CMB Meeting Minutes #172

REFERENCE Project No. M544.1, Contract No. 149 Task 1-8.02

SUBJECT: Configuration Management Board Meeting # 172 – Rev. No. 0

Phase 3

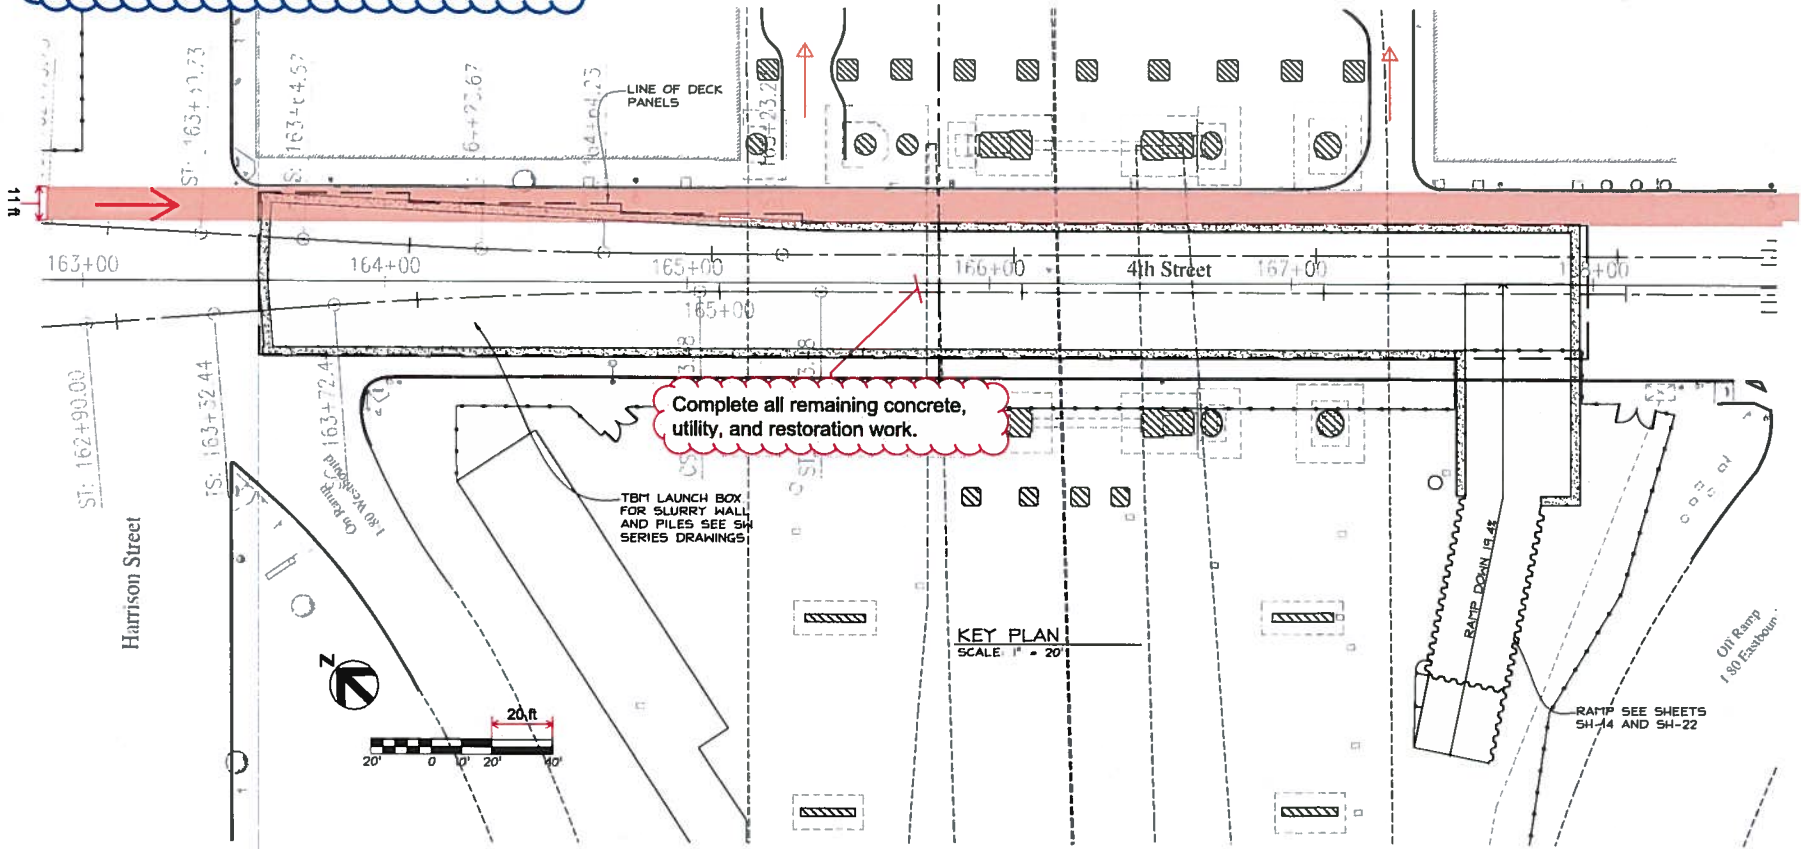
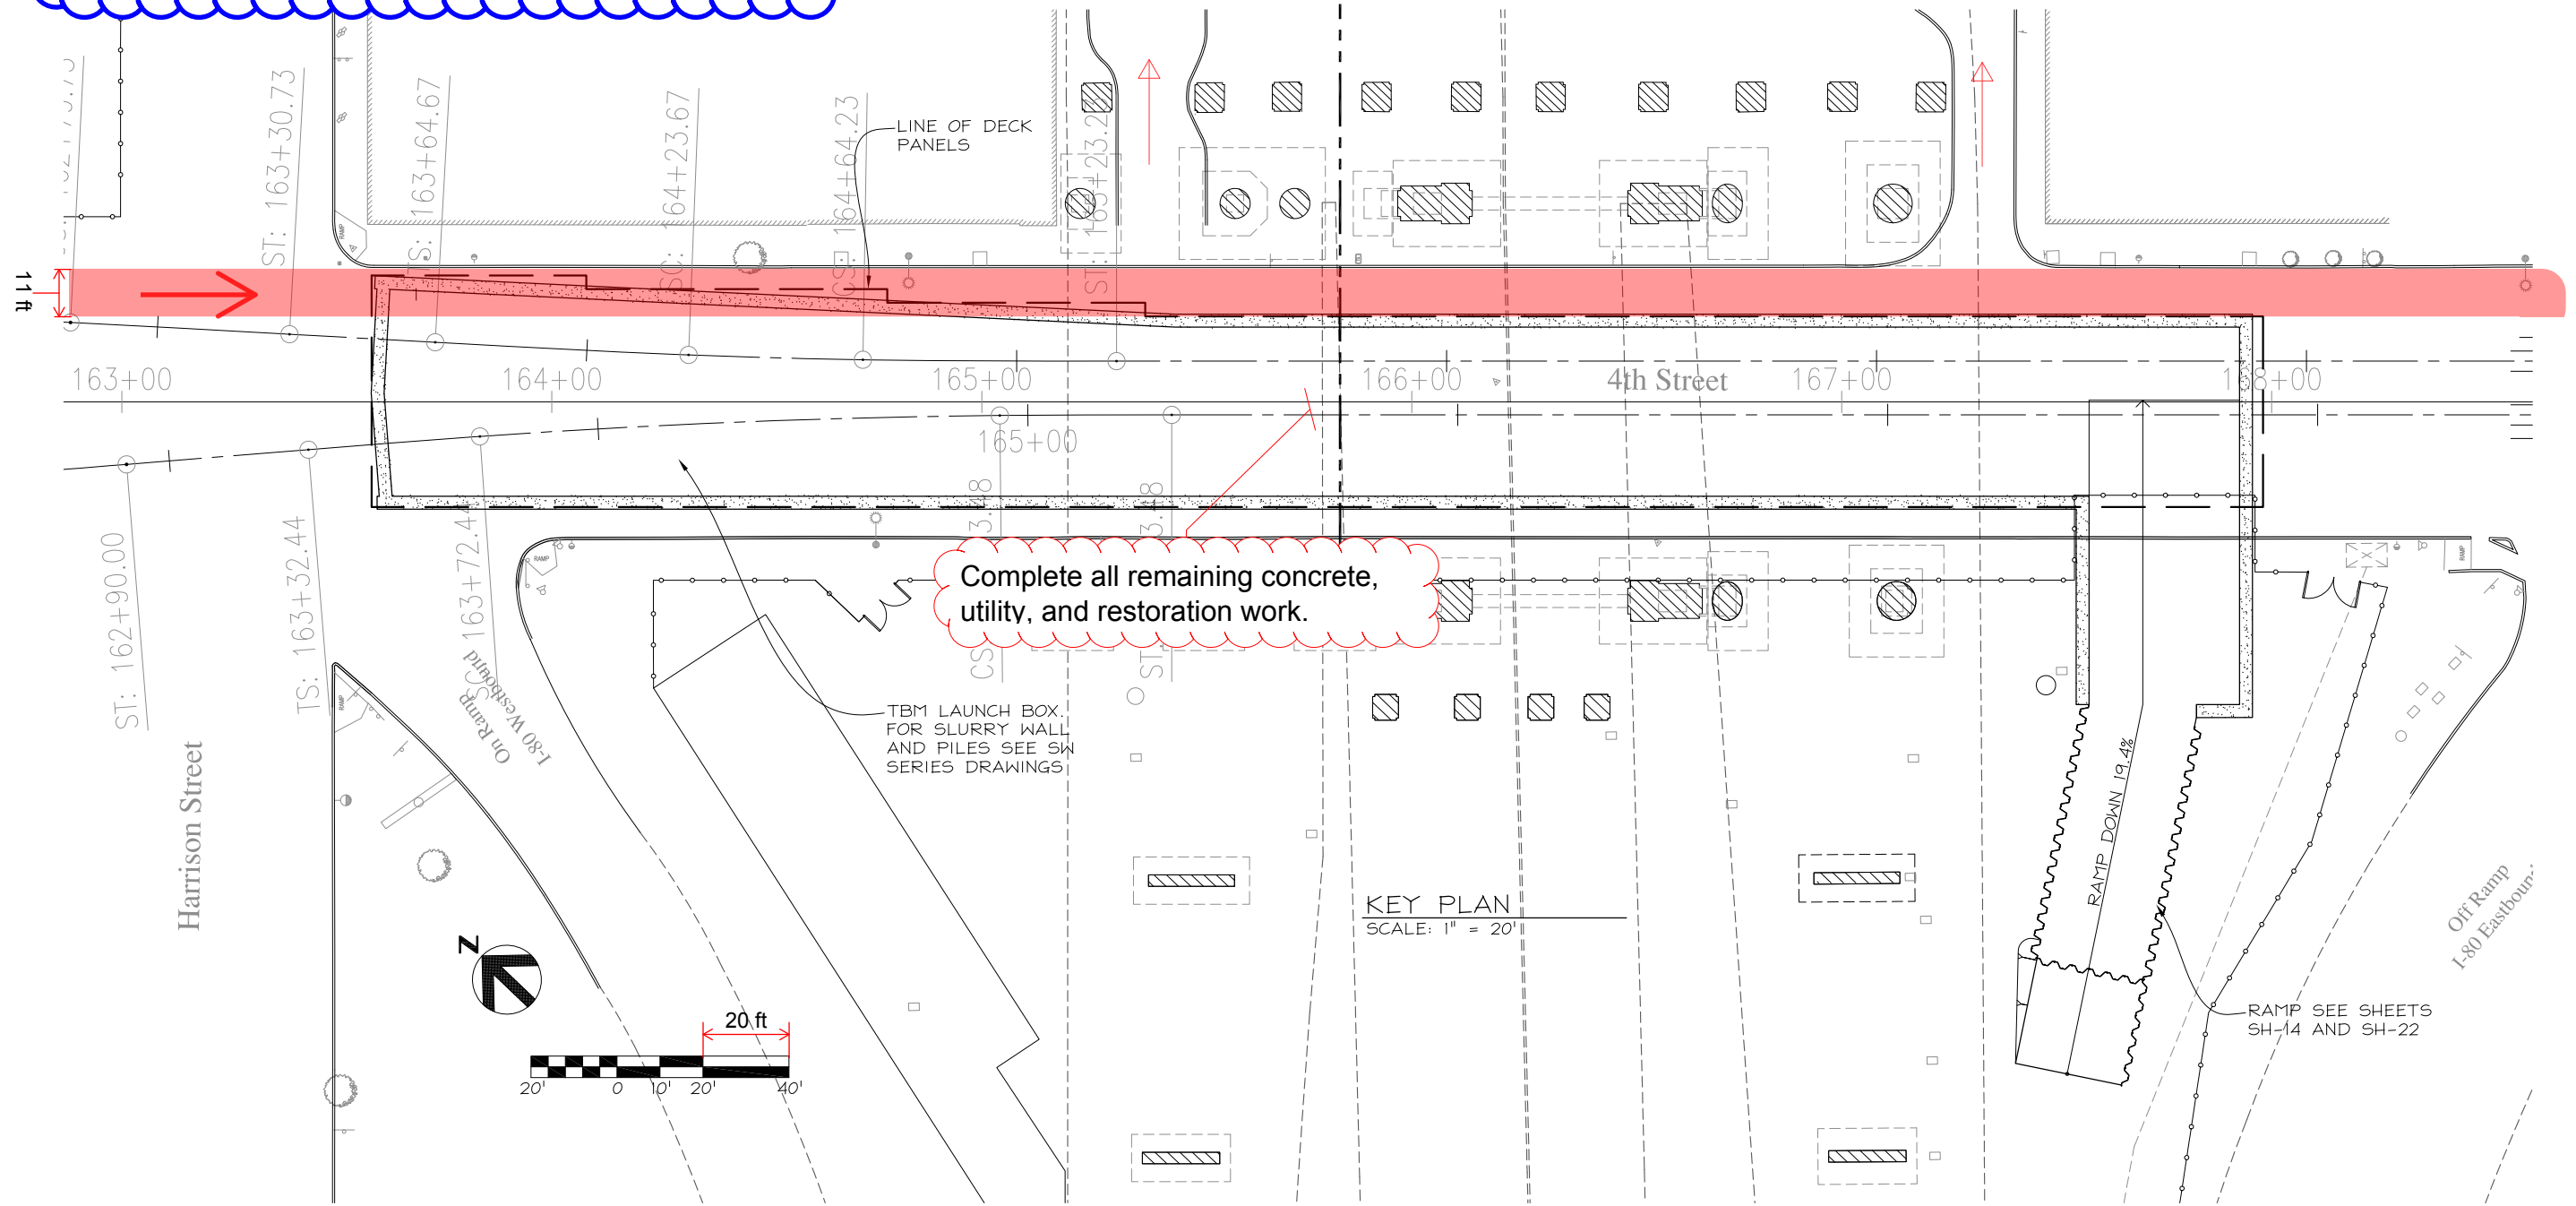
- Single Lane East Open
- Late December Until Restoration Complete

ORIGINAL METAL STRIP

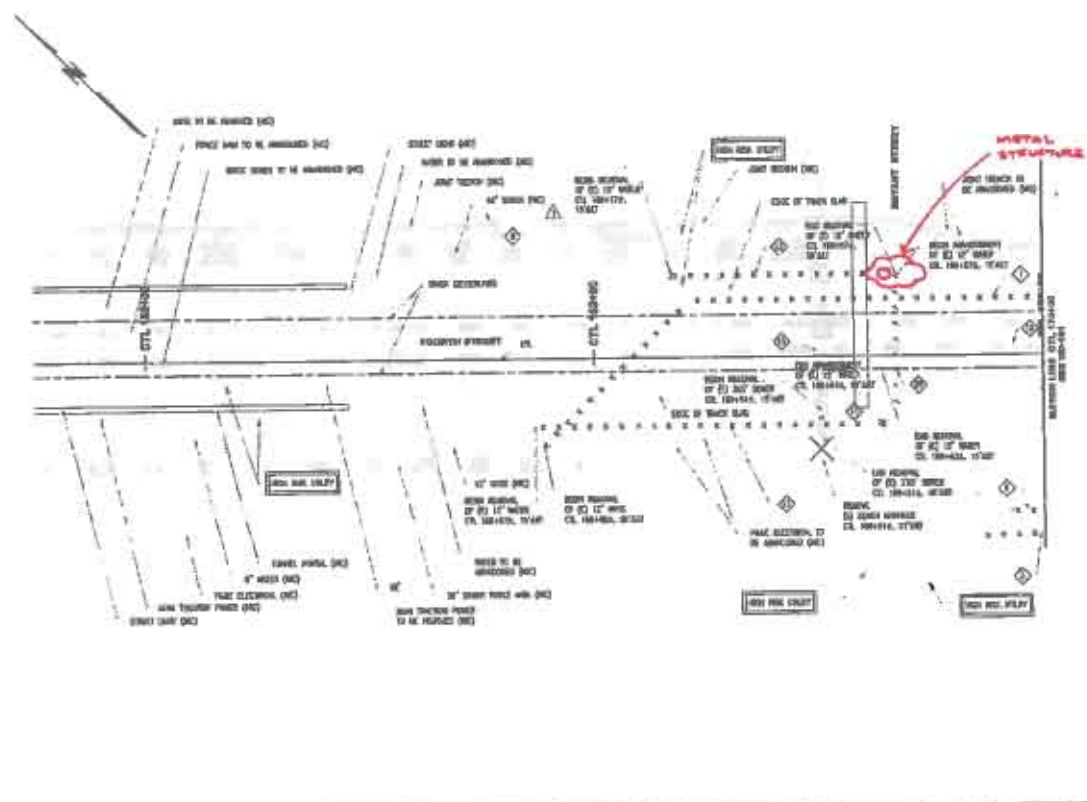
Location: Southeast corner of Bryant and 4th St.
Nature and Extent: During our potholing investigation, we found an unknown existing metallic utility structure in the alignment of the existing 12" water distribution line. Size is unknown. Attached are drawings and pictures.
How conditions affect work: Depending on the size of the structure, it will affect the removal of the existing 12" waterline. May require additional excavation, shoring, haul away, dump fees, backfill, and street restoration.
Recommendations: SFMTA/Water dept identify the structure and provide size. If SFMTA/water dept are unable to do so, direct the contractor to perform additional potholing and remove the structure if feasible as change order work.
Baseline conditions: The UD-400 plan does not show removal of a structure at that location.
